RPAC St Catherine's School S4.55 Access Report

This S4.55 Access Report provides a review of access related changes in relation to the amended Phase A program.

Level 2 modified amenities

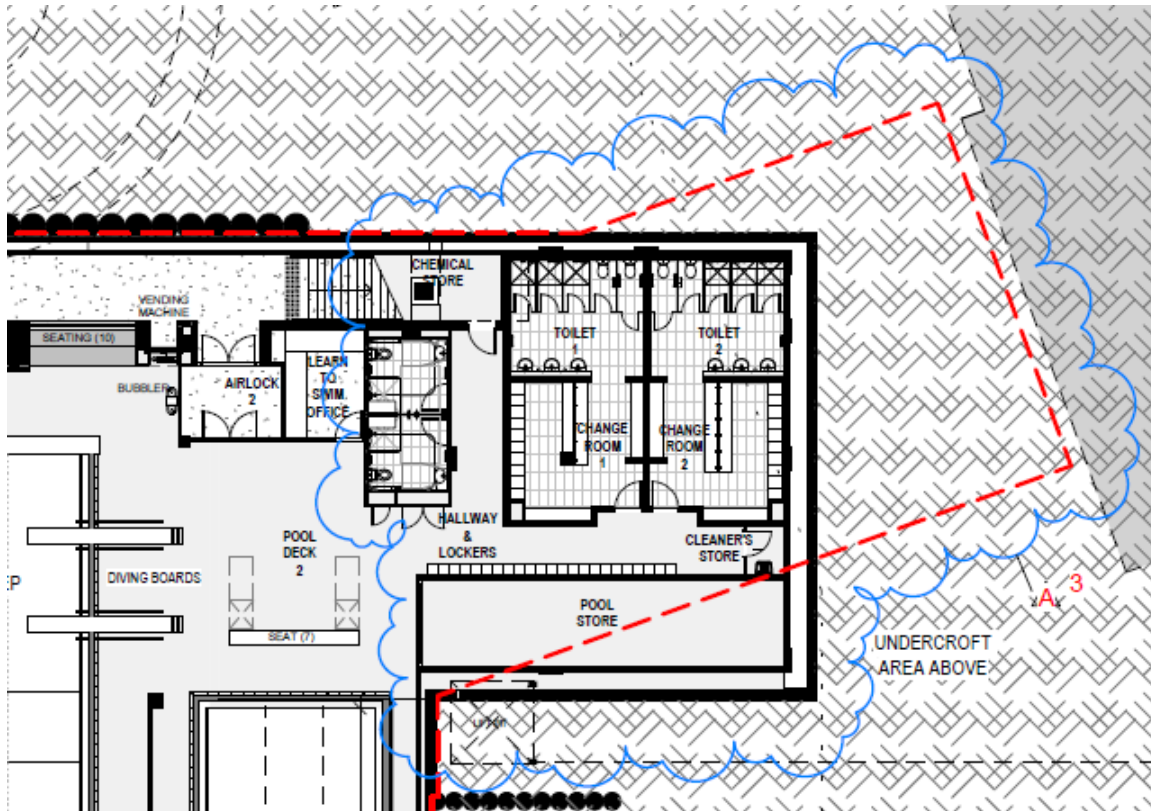
Reoriented amenities at NW pool deck, including accessible unisex toilets and PAD cubicles (to assist persons with ambulant disabilities).

Level 2	Access criteria APS, BCA & Standards
Path of travel (POT) Entries, signage & doors Stairs, ramps, bollards, passenger lifts & signage	Comply with Level 1 access criteria
Seating	<i>Recommendation – provide minimum 20% seating with backs and armrests, and adjacent wheelchair seating spaces</i>
Ramps, stairs & signage	Comply with Level 1 access criteria
Amenities	Provide complying unisex accessible toilets and showers Install PAD cubicles in gender specific toilets (to assist persons with ambulant disabilities)
Counters	<i>Recommendation – provide minimum 1m wide accessible counter section 850 ±20 high</i>
Pool access	Provide complying accessible water entry / exit for swimming pools

Level 2 Macpherson St east frontage

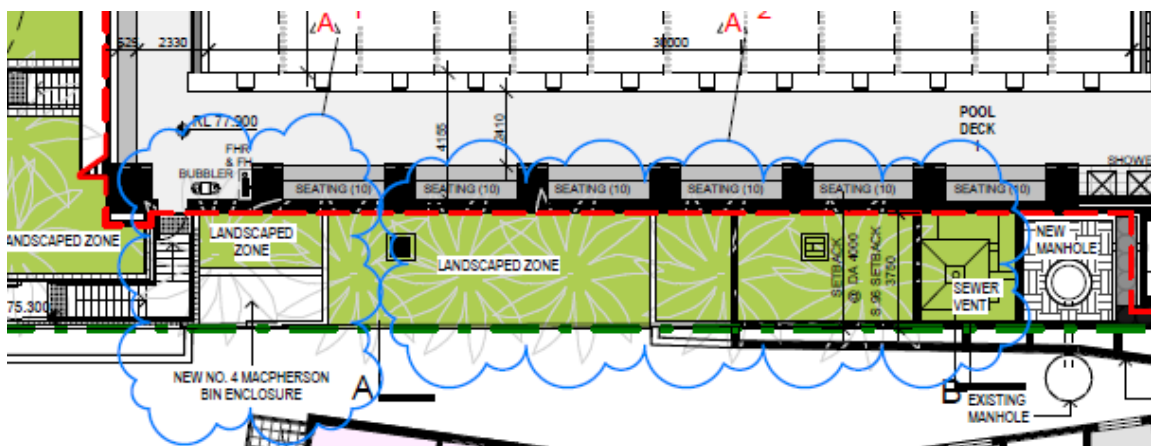
Modified Macpherson St east frontage landscaping.

Level 3 modified NW fitness area and site works

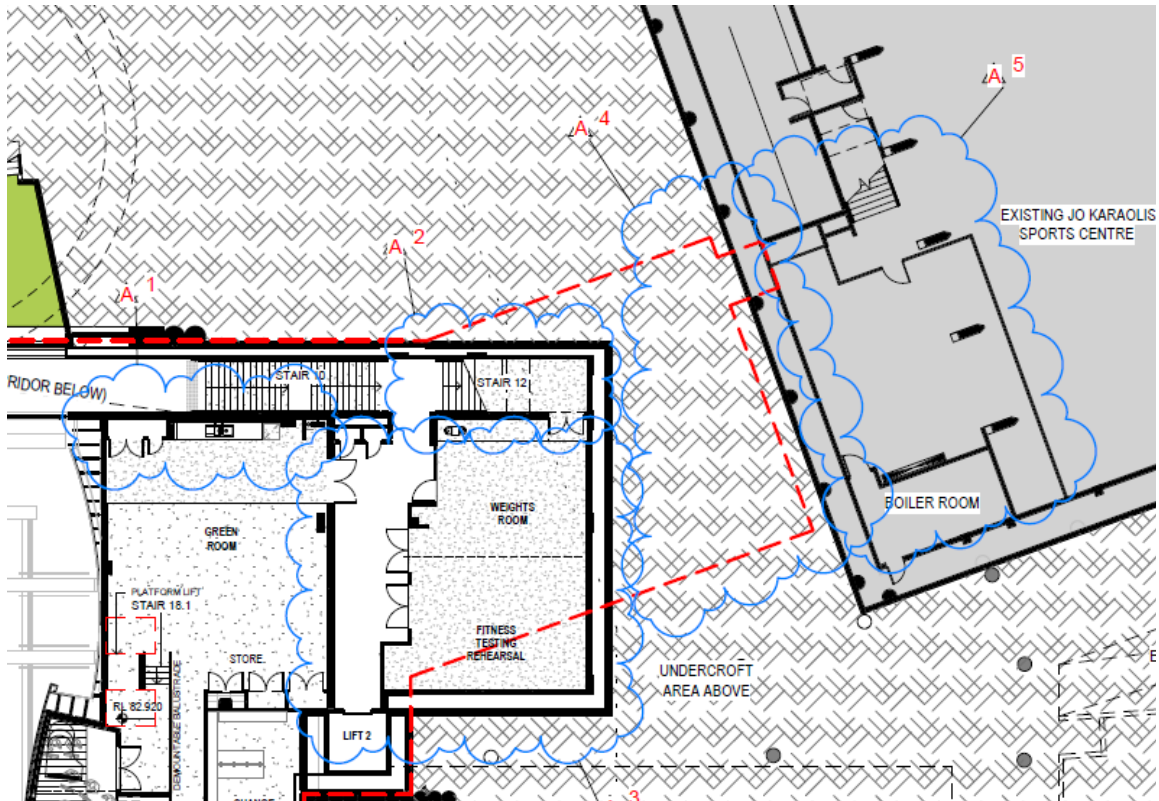
Modified north fitness areas.

Relocated stair 12 link to Sports Centre.

Level 3	Access criteria APS, BCA & Standards
Path of travel (POT) Entries, signage & doors Stairs, ramps, bollards, passenger lifts & signage	Comply with Level 1 access criteria
Amenities	Comply with Level 2 access criteria

Level 4 modified site works and Sports Centre access

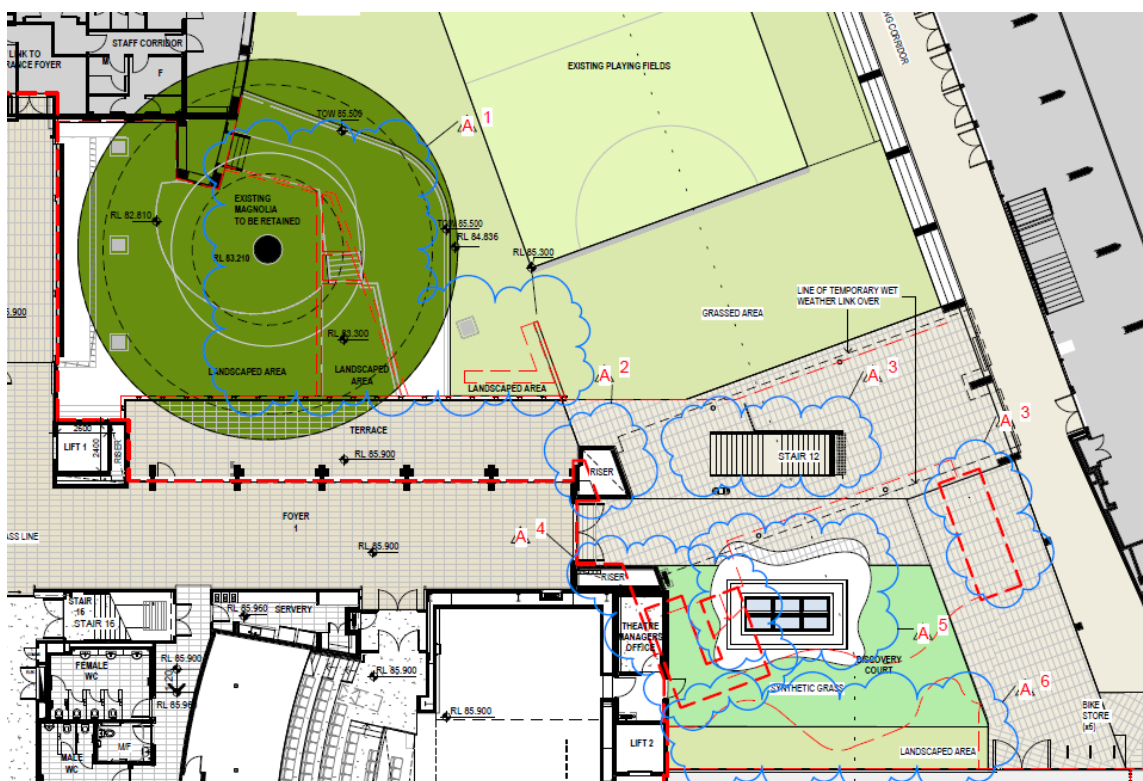
Modified paving and levels adjacent to courtyard magnolia tree to be retained.

Relocated stair 12 link to Sports Centre.

Discovery court with synthetic grass.

Modified landscaped areas.

Pair of doors x 2 to auditorium lower east and west entries.

Level 4	Access criteria APS, BCA & Standards
Path of travel (POT) Entries, signage & doors Stairs, ramps, bollards, passenger lifts & signage	Comply with Level 1 access criteria Provide level junctions between new and existing paving
Amenities	Comply with Level 2 access criteria
Auditorium	Provide complying wheelchair seating spaces with adjacent companion seats, and equitable access to the stage
Counters	Comply with Level 2 access criteria
Platform lift	Provide complying circulation space, minimum 900 wide door, 1100 x 1400 car size, Braille & tactile momentary pressure controls 990 to 1200 high, handrails and usable without a key during normal school operation hours

Level 5 Modified NW roof and landscaped areas

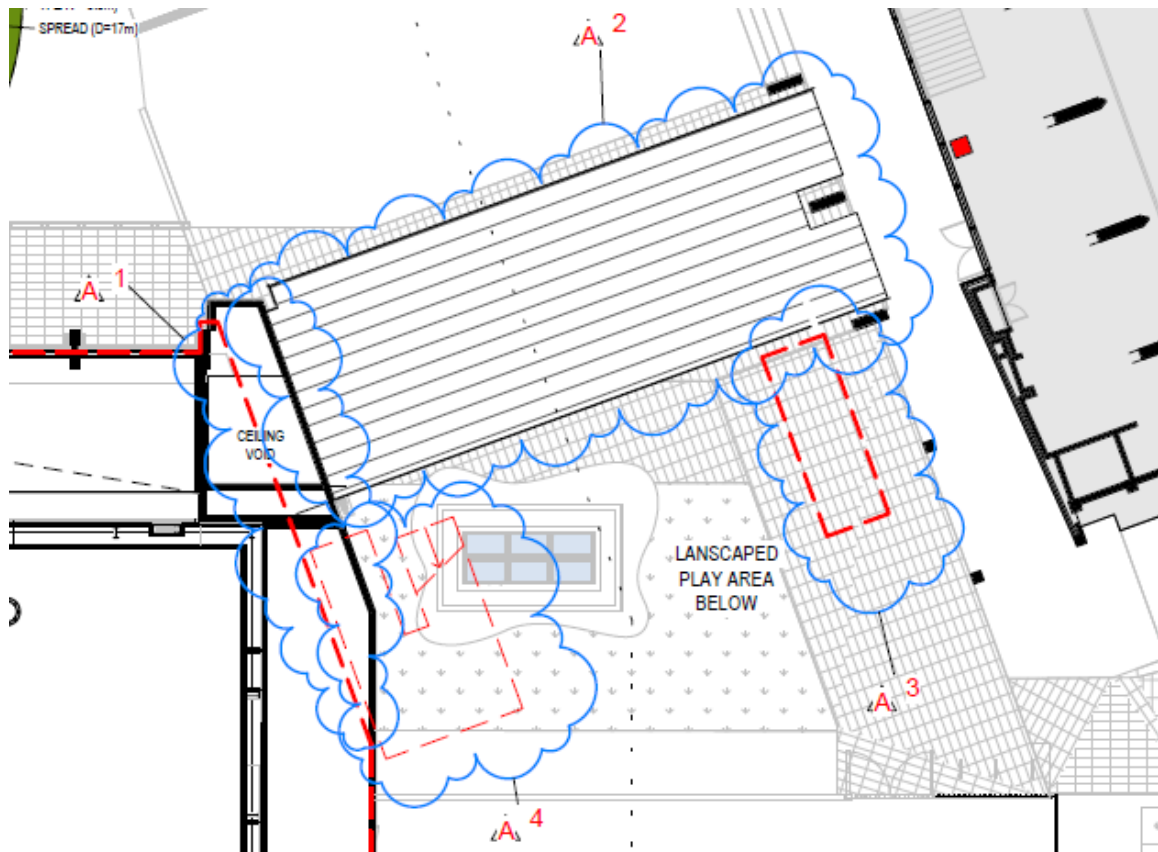
Modified roof over new link to Sports Centre.

Modified landscaped areas.

Level 5	Access criteria APS, BCA & Standards
Path of travel (POT) Entries, signage & doors Stairs, ramps, bollards, passenger lifts & signage	Comply with Level 1 access criteria
Kitchenette	Comply with Level 2 access criteria
Platform lift	Comply with Level 4 access criteria

Level 6 Modified NW roof and landscaped areas

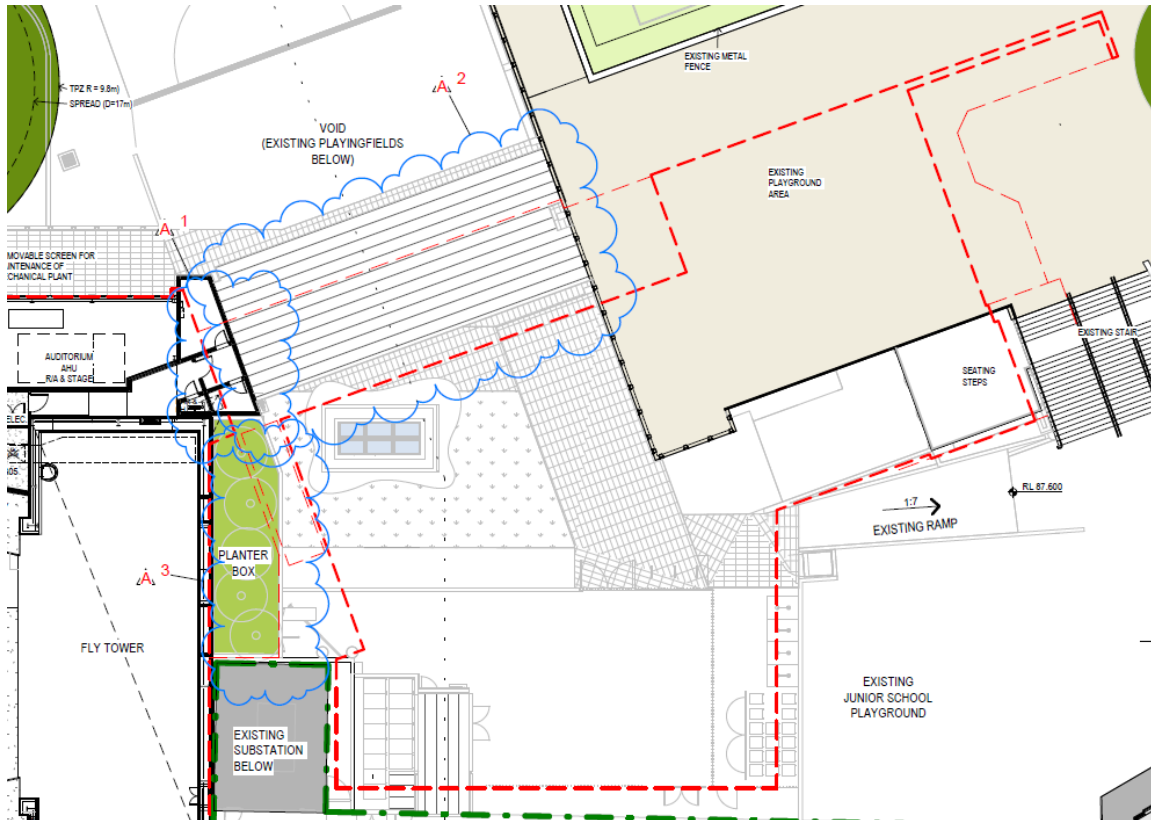
Library excluded from Phase A.

New NW roof and landscaped areas above Sports Centre link.

Level 6	Access criteria APS, BCA & Standards
Path of travel (POT) Entries, signage & doors Stairs, ramps, bollards, passenger lifts & signage	Comply with Level 1 access criteria
Auditorium	Comply with Level 4 access criteria
Amenities	Comply with Level 2 access criteria

Level 7 Modified NW roof and landscaped areas

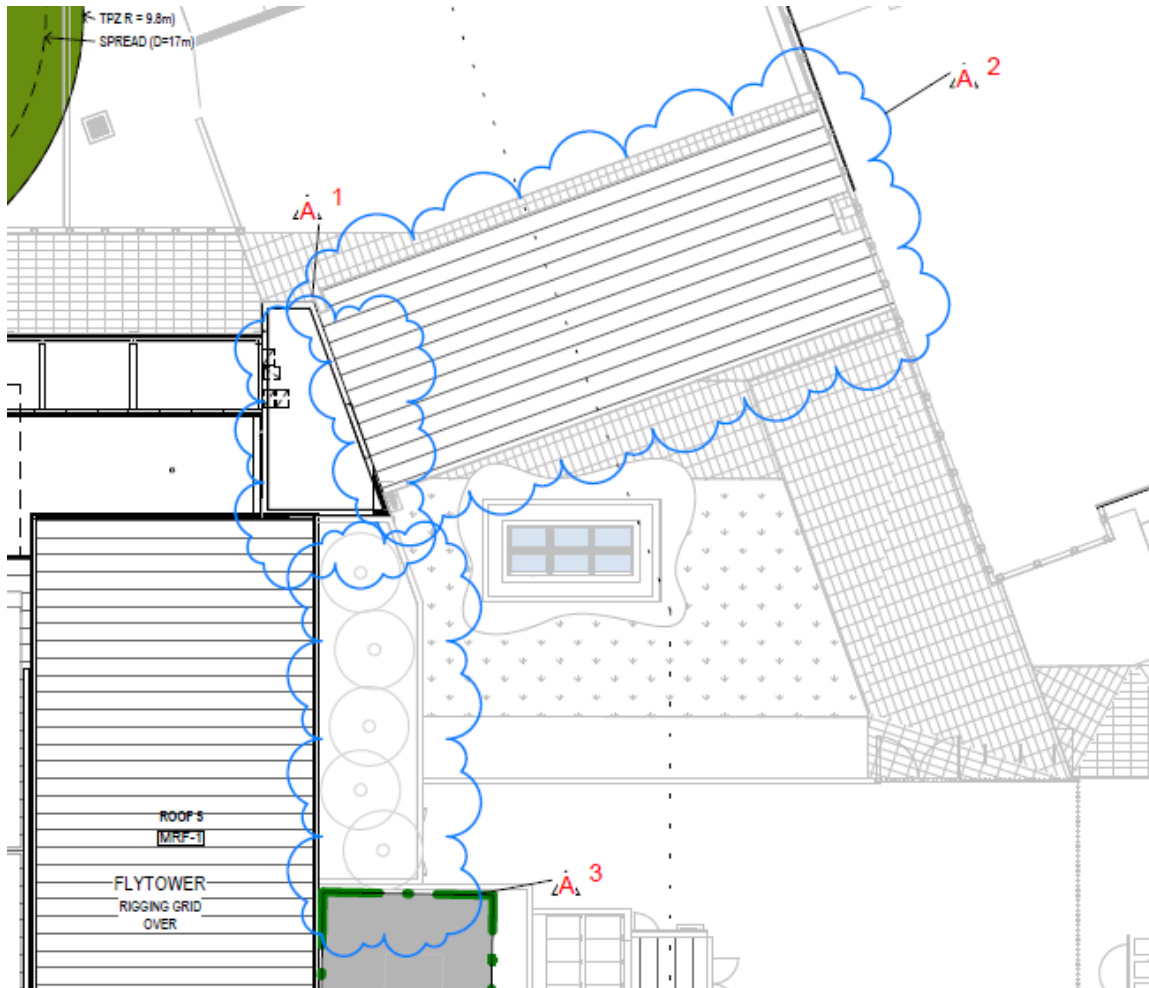
New NW roof and landscaped areas above Sports Centre link.
